## FINAL REPORT

### SAFETY INJECTION SYSTEM PIPING DEFICIENCY

May 30, 1980

FIGURE - 1

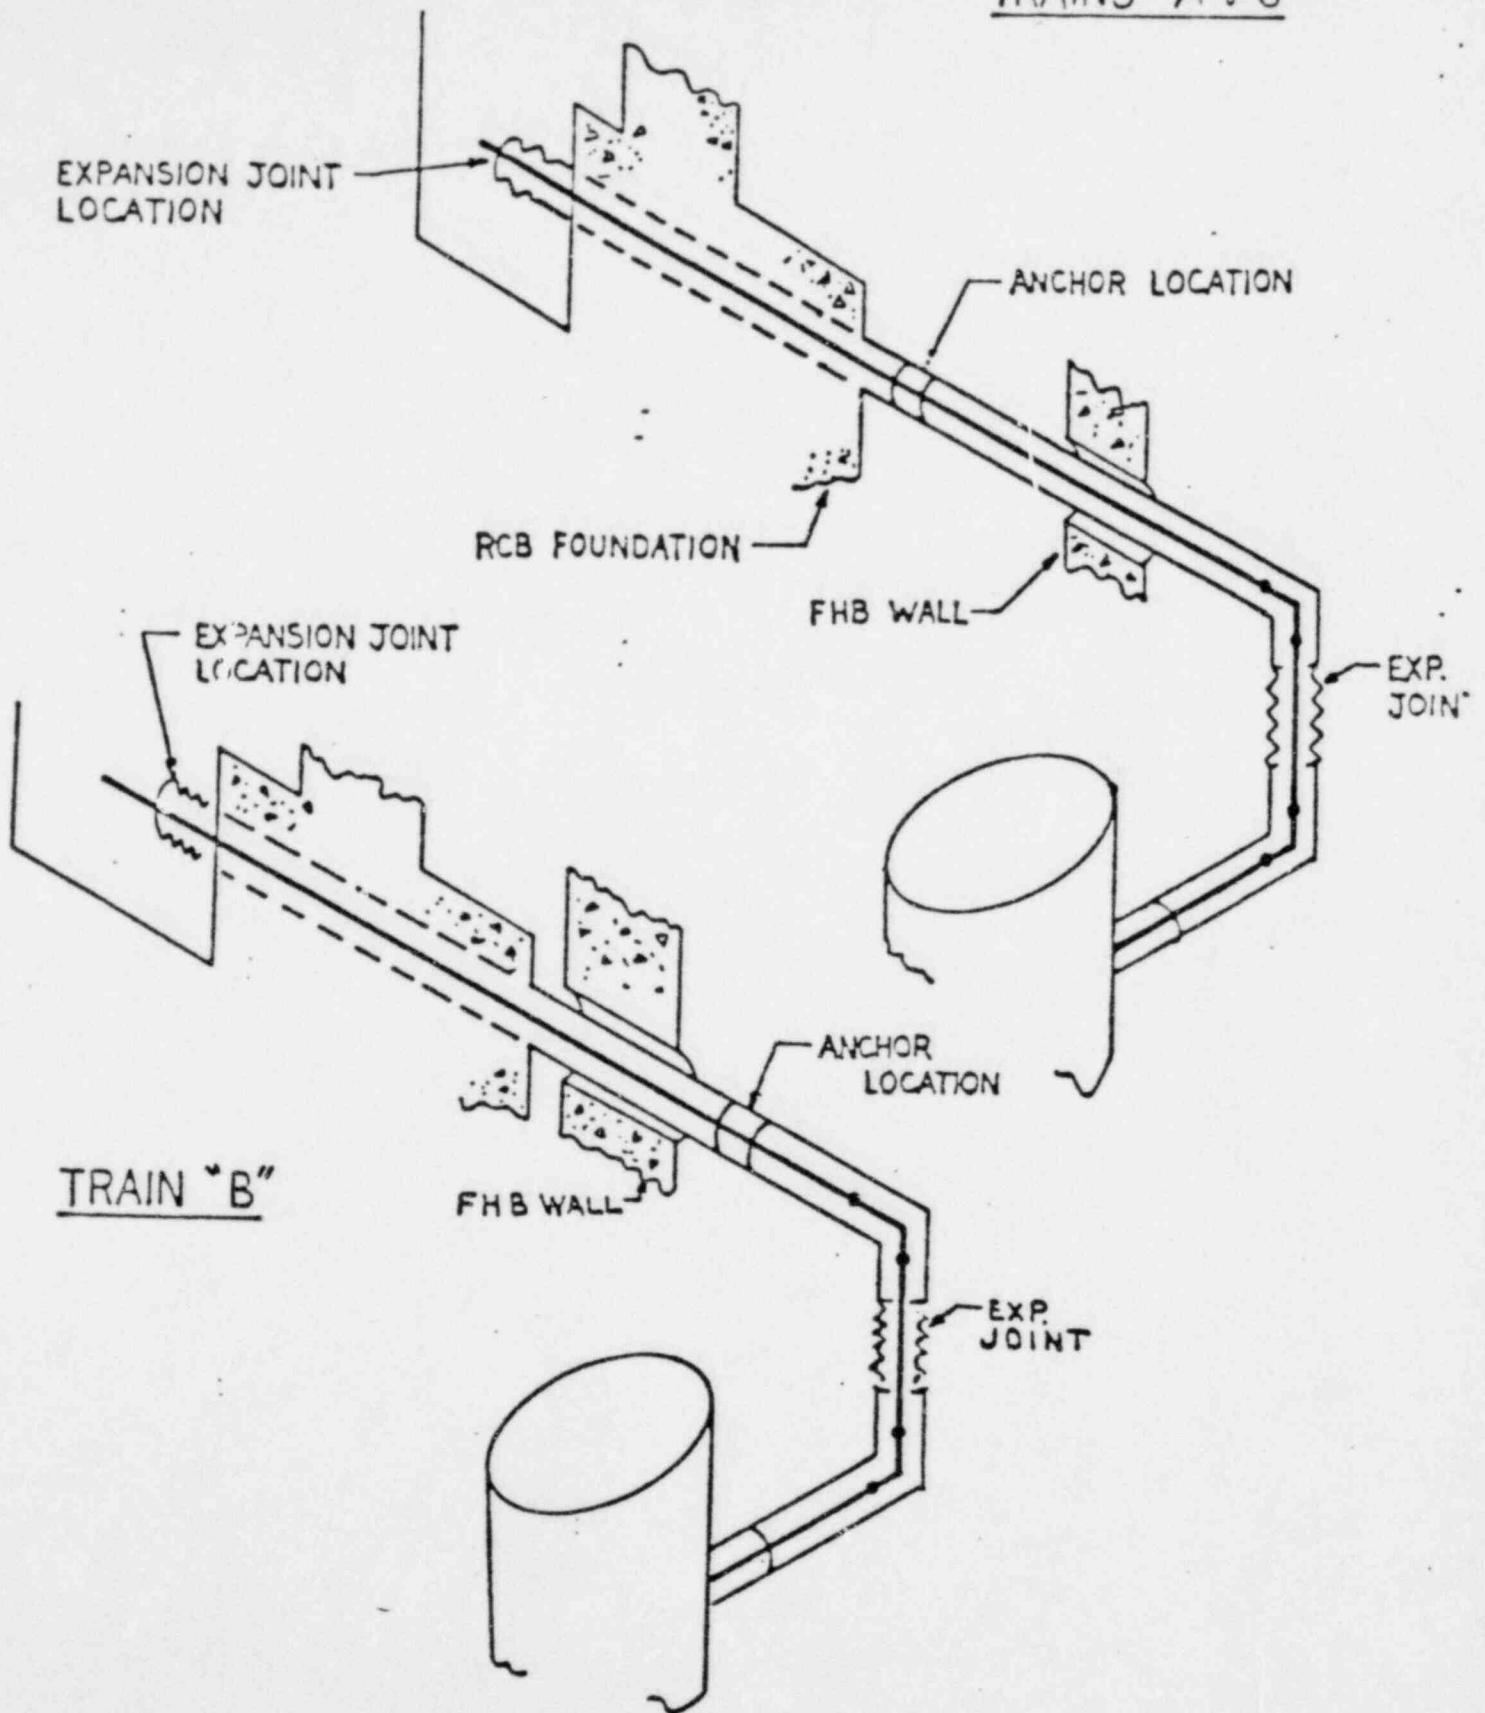
During a routine review, a design deficiency was discovered which, if left uncorrected, could have adversely affected the safety of operations. The joint between the 16 inch Safety Injection System piping and the emergency sump liner was shown on the construction drawing to be a one-quarter inch seal weld, which does not meet the design load criteria.

If this deficiency were to have been left uncorrected, the weld at sump liner/process pipe interface could fail. The process pipe would then be free of restraint and would impose a load on the recirculation valve which exceeds the allowable end loads. It could not then be guaranteed that the valve would operate as required. Because this problem affects all three trains, this is a common mode failure which could cause loss of safety system functions.

This deficiency will be corrected by anchoring the process pipe to the guard pipe outside the containment building and adding an expansion joint to the process pipe inside the emergency sumps (see Figure 1).

In determining that this installation is acceptable, the following factors and limitations were checked and verified as satisfactory:

- Pipe Stresses
- Recirculation Valve End Loads
- Safety Injection Pump Load Limits
- Sump Liner Load Limits
- Containment Penetration Sleeve Load Limits
- Differential Settlement Criteria
- Containment Pressure Boundary Continuity
- Process Pipe and Guard Pipe Should Not Impact During a Seismic Event
- Constructability.
